# UNITED STATES PATENT AND TRADEMARK OFFICE

# Office Action Summary

10/661,847

## **DETAILED ACTION**

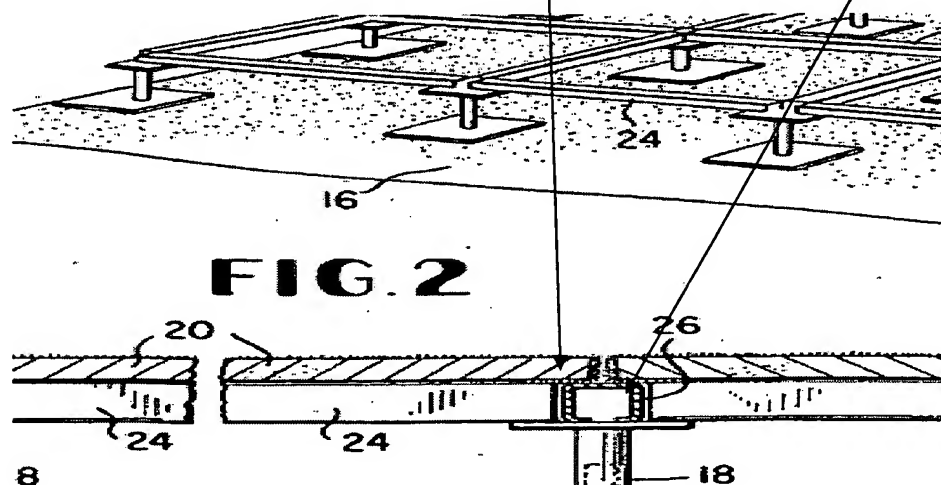
Anthony does not appear to expressly disclose;

that there is at least one groove in said bottom surface,

each said groove is sized to engage one of said support beams where a portion of said beam is positioned in said groove and

said removable support plate is in direct contact with said beam.

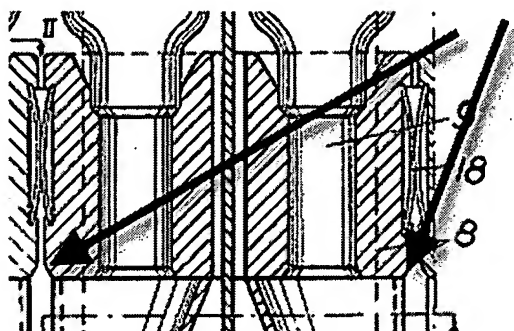
Further, Sodergard does indeed disclose a groove on the bottom as shown here
